**BAT Plan_Woodbine Crossing, Lot 4
723 Woodbine Crossing Road
Mount Airy, MD 21771**

RE: Lot 4 Site Plan for BAT Installation
723 Woodbine Crossing Road
Woodbine Crossing Subdivision

**PLOT PLAN
SITE PLAN FOR BAT TECHNOLOGY
LOT 4
WOODBINE CROSSING**

LATERAL DETAIL
NOT TO SCALE

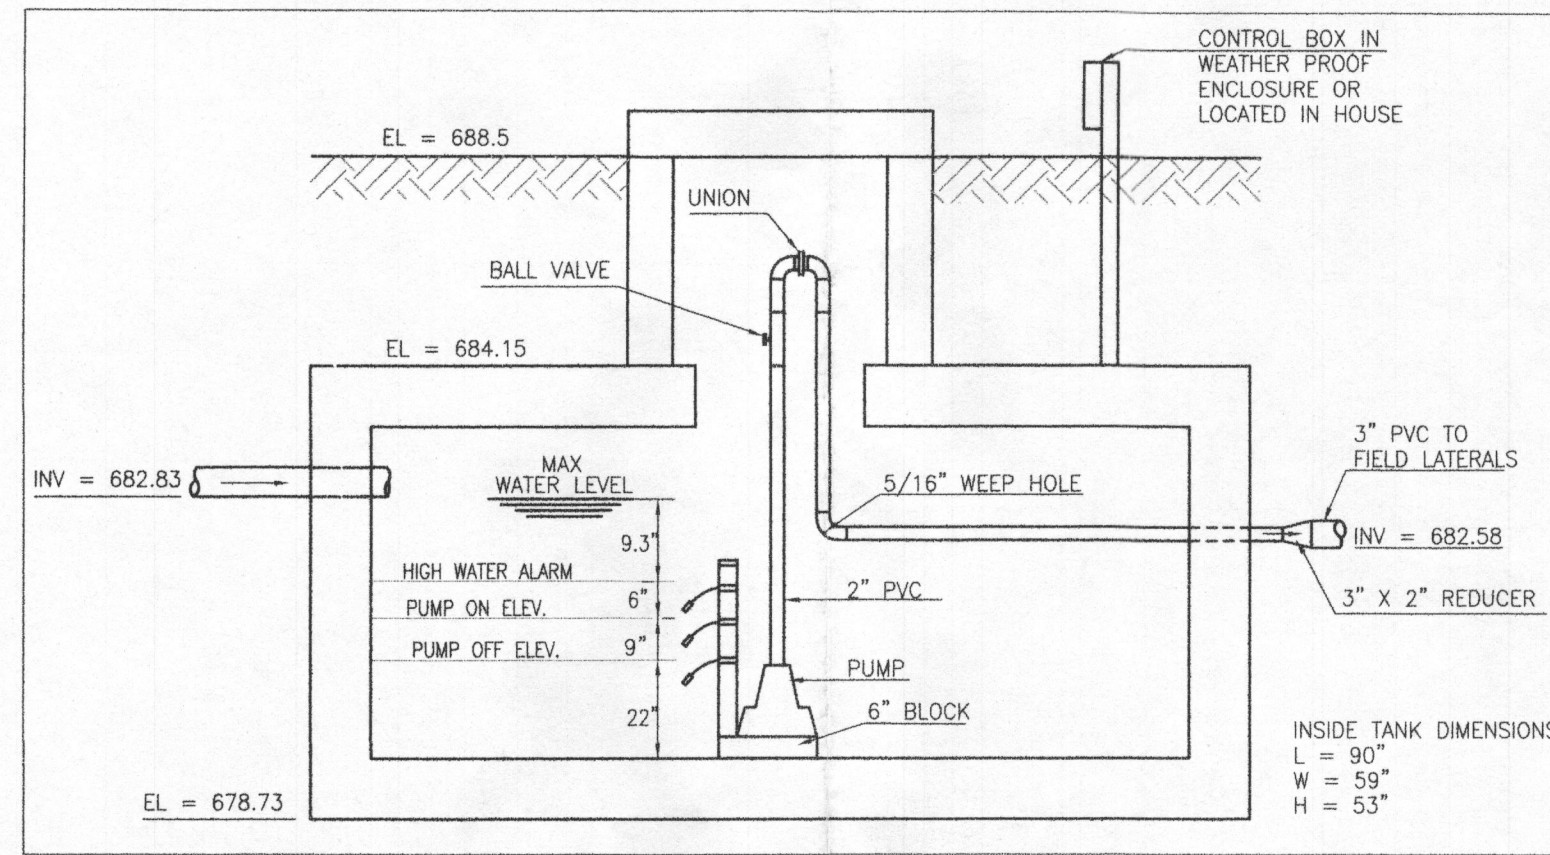
- 2.) It's unclear to me where the # of fittings came from. If you could provide more information in the Lateral Detail drawing, I think this would help with the installation of the system and clarify how connections are made. For instance, show how the FM enters the manifold etc.

Response 2: A Fittings Diagram has been added.

HYDRAULIC GRAPH

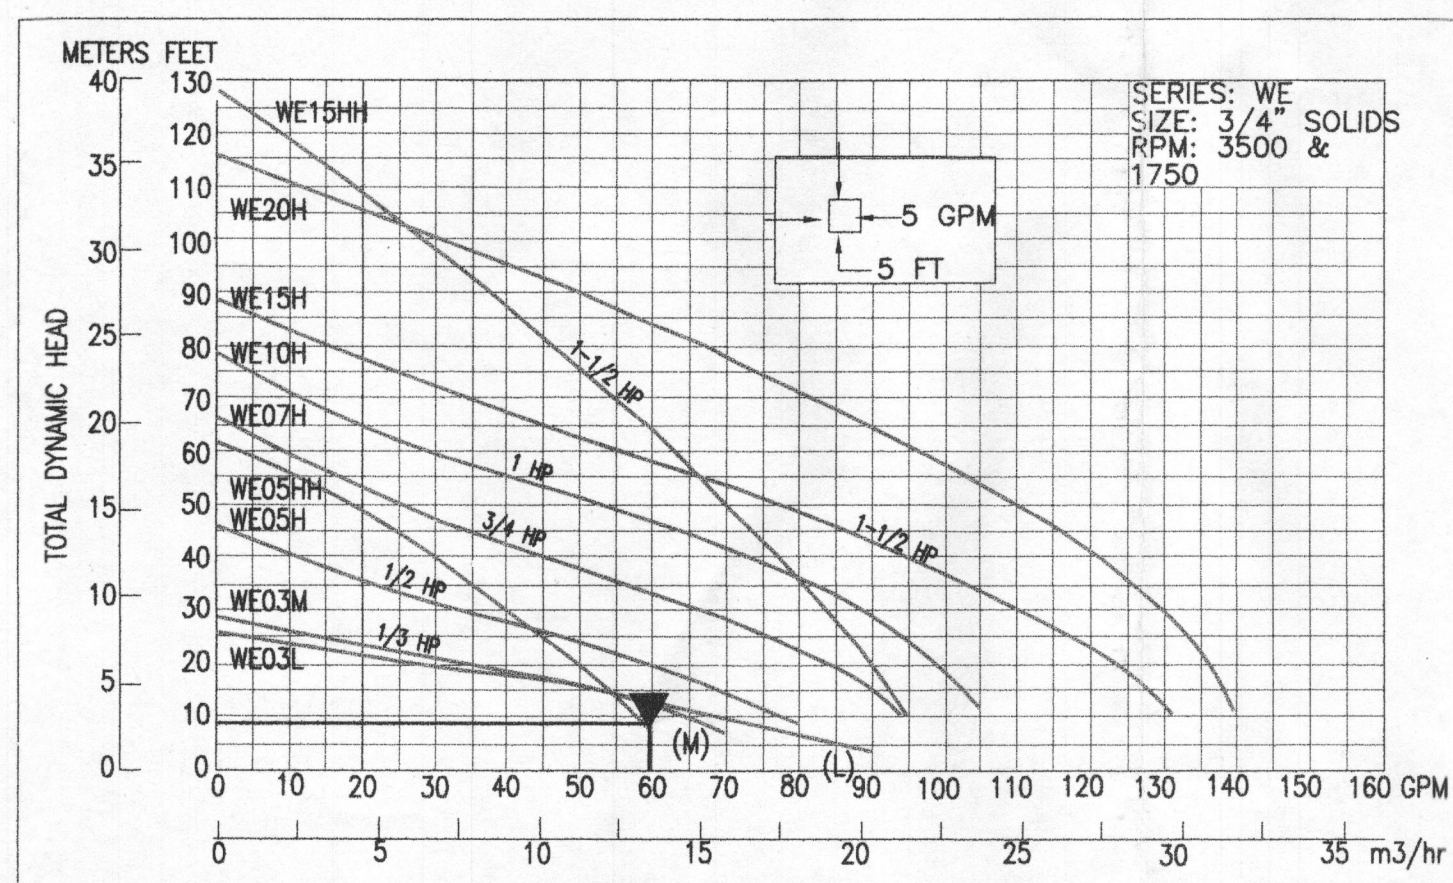
- 4.) Distal Head figures should all be the same (probably all = 2.0), if the pipe inverts are the same.
- 5.) Based on the GPM, the pump is placed at the end of the performance curve. It's recommended that the # of orifices is decreased to 5 and the spacing increased accordingly so the point on the Hydraulic Graph falls under the ½ or 1/3 HP performance curve. This will make the dose smaller and kick the pump on more often which is better for the system. Also,

Response 5: The number of orifices was decreased to 5. This provided a 59.7 gpm at the 1/3 HP. We

have proposed using the WE03M
